REMARKS

Reconsideration of the application in view of the above amendments and the following remarks is requested. Claims 2-5, 8-10, 26, 33-36, and 45-55 are in this application. Claim 6 has been cancelled. (Claims 1, 7, 11-25, 27-32, and 37-44 were previously cancelled.) Claim 52 has been amended to correct an inadvertent error. Claims 2-5, 8-10, and 45-49 have been allowed.

Applicant requests the Examiner's permission to make the changes shown in red on the annotated copies FIGS. 3B, 4B, 5B, 6B, 7B, 8B, 9B, 10B, 11B, and 12B attached to this amendment in Appendix A. The changes to the drawings include the addition of a number of reference numerals to label structures shown within the drawings. The specification has also been amended to reflect the changes to the drawings. In addition, applicant has also attached a replacement set of drawings in Appendix B that include replacement sheets for the figures which have been amended, along with copies of the formal drawings filed on July 30, 2002.

FIG. 12B

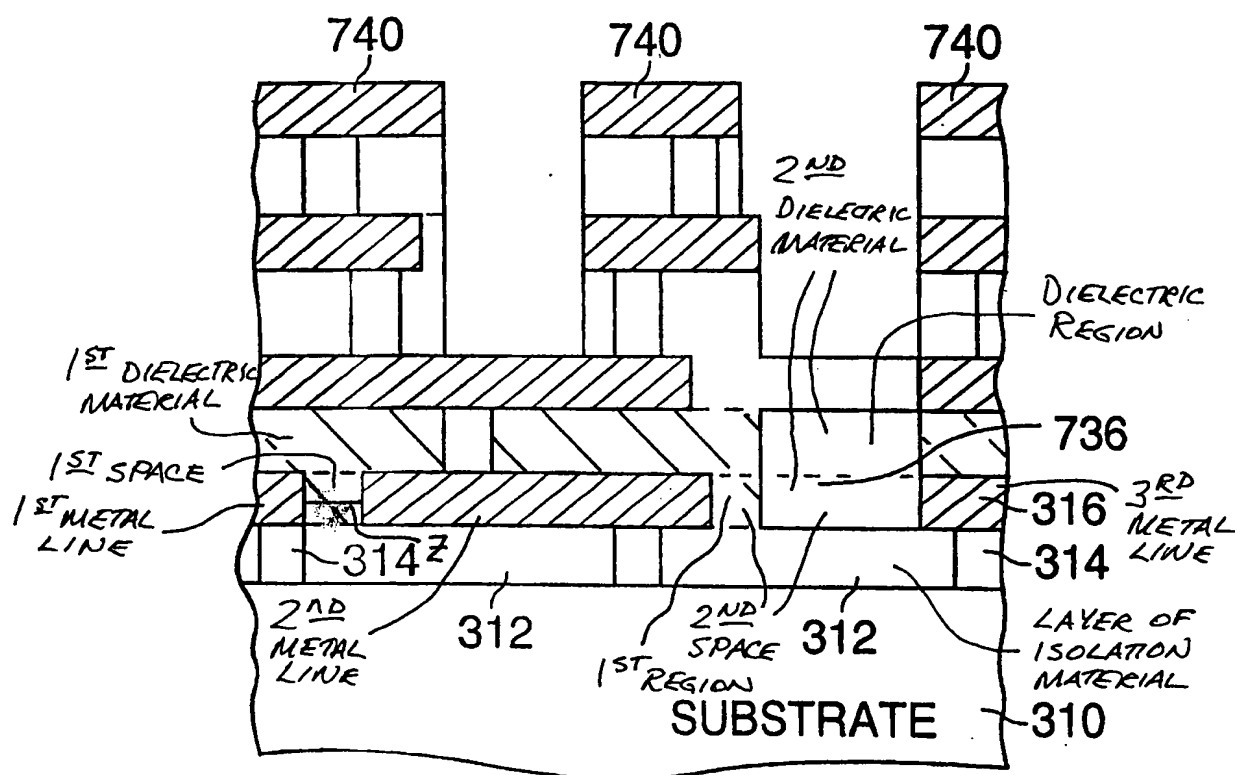
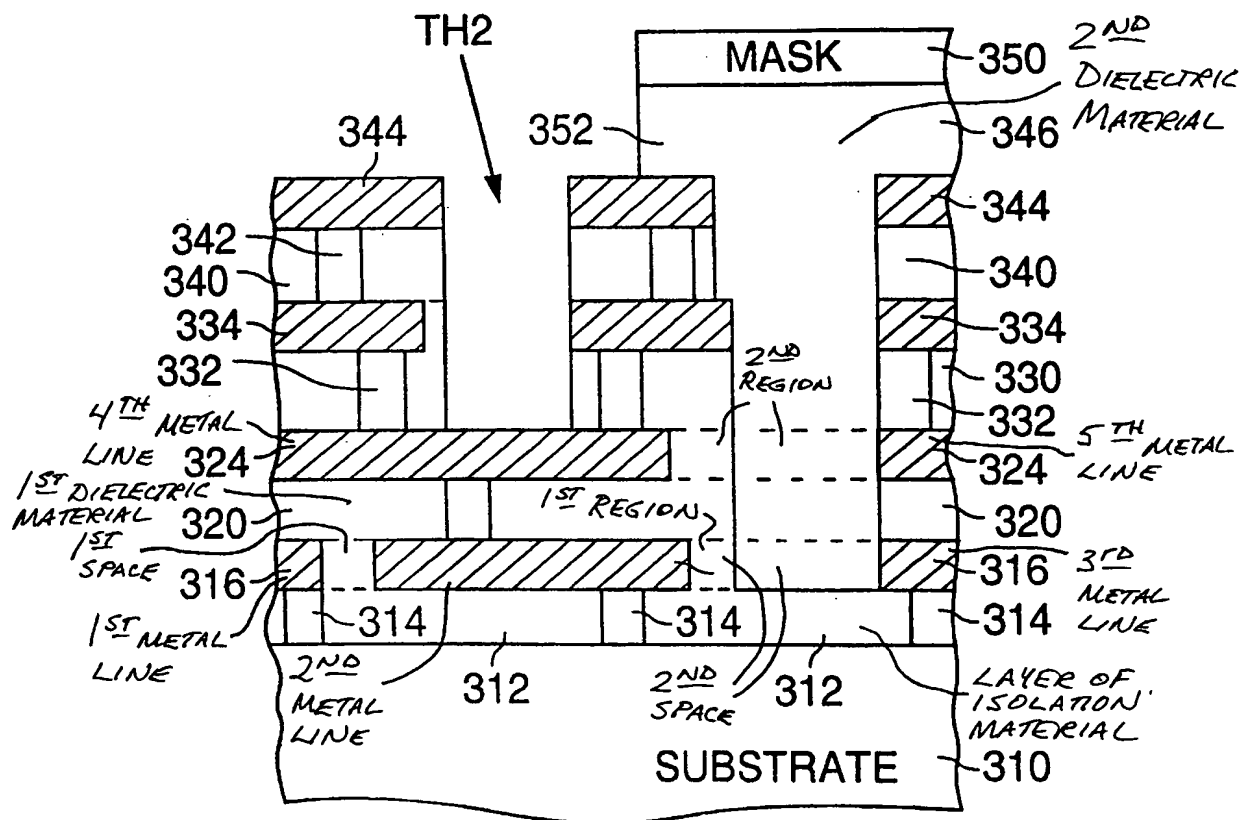
The Examiner rejected claims 26, 33-36, and 50-55 under 35 U.S.C. §112, first paragraph. With respect to claim 26, the Examiner argued that the specification does not disclose a first dielectric material that lies in a first region that lies horizontally entirely between the second and third metal lines. The Examiner also argued that the specification does not disclose a second dielectric material that is formed over the first region.

In responding to applicant's comments in the last amendment, the Examiner stated:

"The specification (fig. 12b) discloses the first dielectric material (312) lies in a portion of a first region that lies horizontally between the second and third metal lines. Additionally, the specification (figure 12b) also shows

another dielectric material (736) lies between the portion of a first region of second and third metal lines. Therefore, how can the first dielectric material (312) lies horizontally entirely between the second and third metal lines when another dielectric material (736) lies in the same horizontal between the second and third metal lines?"

Applicant has included an annotated version of applicant's FIGs. 12B to aid in the following discussion. With reference to the annotated drawing, FIG. 12B shows an isolation layer, which is labeled "layer of isolation material", and a metal-1 layer with a left metal line, a center metal line, and a right metal line that are labeled first, second, and third metal lines, respectively.

In addition, FIG. 12B shows an area labeled first space, which is defined to lie between the first and second metal lines, and an area labeled second space, which is been defined to lie between the second and third metal lines. Applicant brings the

Examiner's attention to the fact that the second space lies "horizontally entirely between the second and third metal lines." Further, within the second space, an area labeled first region has been defined to contact the side wall surface of the second metal line.

FIG. 12B also shows a dielectric material layer, which is the hatched region labeled first dielectric material, and a dielectric structure, which is labeled second dielectric material. In addition, within the dielectric structure (labeled second dielectric material), a dielectric material block, labeled dielectric region, can be defined.

Thus, FIG. 12B shows a layer of isolation material, first, second, and third metal lines, a first dielectric, and a second dielectric. Further, FIG. 12B shows first and second spaces, a first region, and a dielectric region. As a result, applicant's specification necessarily discloses a layer of isolation material, first, second, and third metal lines, a first dielectric, and a second dielectric, along with first and second spaces, a first region, and a dielectric region.

The layer of isolation material of claim 26 can be read to be, for example, the area labeled “layer of isolation material” in the annotated version of FIG. 12B. The first plurality of metal lines of claim 26, including the first, second, and third metal lines, can be read to be, for example, the areas labeled first, second, and third metal lines in the annotated version of FIG. 12B.

The first dielectric material of claim 26 can be read to be, for example, the area labeled first dielectric material in the annotated version of FIG. 12B. As shown

in FIG. 12B, the first dielectric material is formed between the first and second metal lines. In addition, a line, such as line Z shown in the annotated version of FIG. 12, contacts the side wall of the first metal line and extends horizontally over to the side wall of the second metal line through the first dielectric material.

Further, the first region of claim 26 can be read to be, for example, the area labeled first region in the annotated version of FIG. 12B. Applicant brings to the Examiner's attention the fact that, as required by claim 26, the first dielectric material shown in the annotated version of FIG. 12B lies in the first region, and contacts the side wall of the second metal line.

The last limitation of the first dielectric material in claim 26 is that the first dielectric material contact the top surface of the second and third metal lines. As shown in the annotated version of FIG. 12B, the area labeled first dielectric material contacts the top surface of the second and third metal lines as required by claim 26. Thus, all of the limitations of the first dielectric material are supported by applicant's specification.

The second dielectric material of claim 26 can be read to be, for example, the area labeled second dielectric material in the annotated version of FIG. 12B. As shown in FIG. 12B, the second dielectric material contacts the first dielectric material. In addition, the dielectric region of the second dielectric material lies over the first dielectric material. FIG. 12B does not show that the second dielectric material within the dielectric region lies directly over the first dielectric material, but claim 26 does not require this. Claim 26 only requires that the second dielectric material lie over and contact the first dielectric material. The second dielectric material shown in FIG. 12B discloses these limitations.

Applicant notes that claim 26 does not recite that the first dielectric material lies horizontally entirely between the second and third metal lines. Rather, claim 26 recites that a first region lies horizontally entirely between the second and third metal lines. Applicant further notes that, like the first region shown in the annotated version of FIG. 12B, there is nothing in claim 26 which requires that the first region of claim 26 occupy all of the volume that exists between the second and third metal lines.

Claim 26 recites that the first region lies horizontally entirely between the second and third metal lines, and that the first dielectric material lie in the first region. The annotated version of FIG. 12B shows that the area labeled first region lies horizontally entirely between the second and third metal lines (and does not consume all of the volume that lies horizontally entirely between the second and third metal lines), and that the first dielectric material lies in the first region.

Thus, from what applicant can determine, claim 26 satisfies the requirements of the first paragraph of section 112. In addition, since claims 33-35 depend either directly or indirectly from claim 26, claims 33-35 satisfy the requirements of the first paragraph of section 112 for the same reasons as claim 26.

FIG. 5B

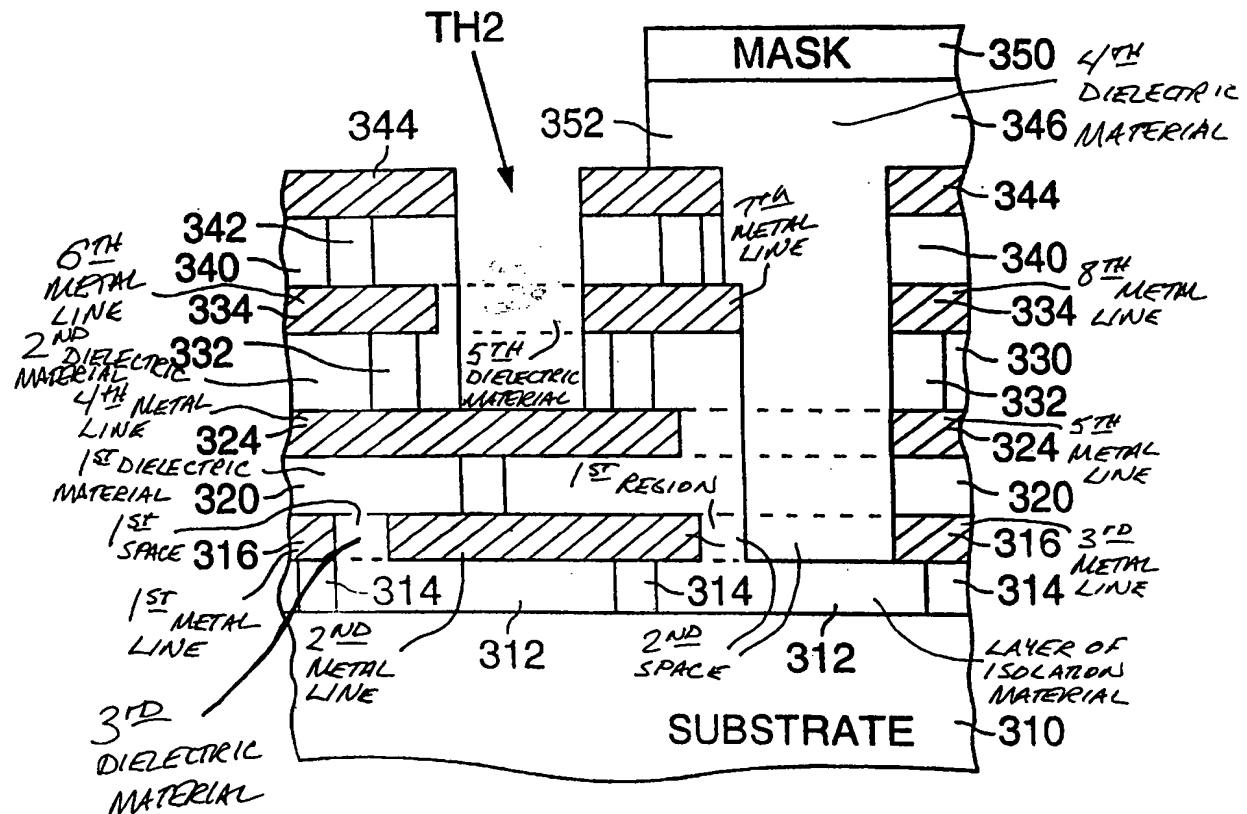
In rejecting claim 36, the Examiner stated:

"The specification never discloses the second dielectric material is formed over the second region as claimed in claim 36. The specification (fig. 12b) discloses the second dielectric material is formed on the fourth metal line and the fifth metal line."

With respect to claim 50, applicant has included a second annotated version of applicant's FIGs. 5B to aid in the following discussion. In rejecting claim 50, the Examiner stated:

"The specification never discloses a fourth dielectric material formed between the second and third metal lines and the fourth and fifth metal lines as claimed in claim 50. How can the fourth dielectric material (346) [be] formed between the second and third metal lines when another dielectric material (312) [is] formed between the second and third metal lines? There are two portions of two dielectric materials (one is 346 and another is 312) formed between the second and third metal lines."

With respect to claim 54, the Examiner stated:

"The specification never discloses [that] the third dielectric material is also formed within a region that lies in the first horizontal plane between the second and third metal lines as claimed in claim 54. How can the third dielectric material (the dielectric material that lies between the left and center metal lines of metal-1 layer 316) [be] formed within a region that lies in the first horizontal plane between the second and third metal lines when another dielectric material (346) [is] formed within a region that lies in the same plane between the second and third metal lines (figure 5B)?

With respect to claim 36, applicant notes that all of the comments set forth above regarding FIG. 12B apply equally well to applicant's FIG. 5B. Thus, claim 26, which claim 36 depends from, reads on both FIGS. 5B and 12B. Applicant has included an annotated version of applicant's FIGS. 5B, which has been marked in the same manner as FIG. 12B, to aid in the following discussion.

With reference to the annotated drawing, FIG. 5B shows a dielectric structure, which is labeled second dielectric material. In addition, a space labeled second region is defined to lie between the fourth and fifth metal lines. Applicant brings the Examiner's attention to the fact that the second region shown in the annotated version of FIG. 5B lies "horizontally entirely between the fourth and fifth metal lines."

In addition, as shown in FIG. 5B, a portion of the second dielectric material lies on and over the second region. FIG. 5B does not show that all of the second dielectric material lies on and over the second region, but claim 36 does not require this. Claim 36 only requires that the second dielectric material lie on and over the second region, which is what is shown in FIG. 5B.

Applicant, however, is unclear which structure the Examiner is reading to be the second dielectric material. Thus, from what applicant can determine, claim 36 is supported by applicant's FIG. 5B and thus satisfies the requirements of the first paragraph of section 112.

It appears from the Examiner's comments that the Examiner believes that claim 50 requires that all of the volume that lies between the second and third metal lines be filled with the fourth dielectric material. Applicant, however, is not aware of any limitation in claim 50 that requires all of the volume that lies between the second and third metal lines be filled with the fourth dielectric material.

Rather, claim 50 requires that the fourth dielectric material be formed between the second and third metal lines, and between the fourth and fifth metal lines. As shown in the second annotated version of FIG. 5B, the fourth dielectric material is formed between the second and third metal lines, and between the fourth and fifth metal lines. This does not, however, prevent another dielectric material from also lying between the second and third metal lines.

As with the discussion of claim 50, claim 54 does not require that the third dielectric material occupy all of the volume that lies between the second and third metal lines. With respect to claim 55, the Examiner appears to have rejected claim 55 because claim 50 was rejected. Thus, from what applicant can determine, claims 50-55 satisfy the requirements of the first paragraph of section 112.

FIG. 6B

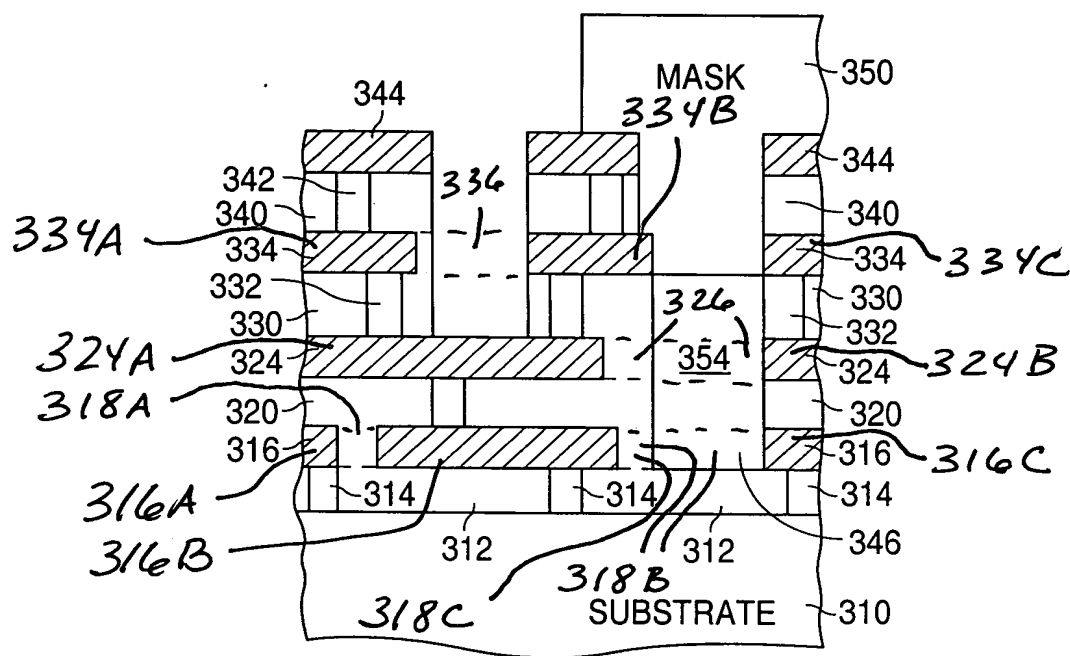
With respect to claim 51, in the last amendment, applicant explained how the sixth dielectric material can be read onto applicant's FIG. 6B. In the present office action, the Examiner indicated that applicant's argument was not convincing because the fourth and sixth dielectric materials are the same. The Examiner also stated that the sixth dielectric material can not be an air dielectric.

Applicant respectfully does not understand the Examiner's arguments. From the Examiner's comments, applicant can only assume that the Examiner believes that for some reason FIG. 6B can not be used to provide support for claim 51. However, applicant does not know if this assumption is correct and, if correct, why the Examiner believes this. Applicant knows of no reason why FIG. 6B can not be

used to provide support for claim 51. With respect to claim 52, the Examiner appears to have rejected claim 52 because claim 51 was rejected.
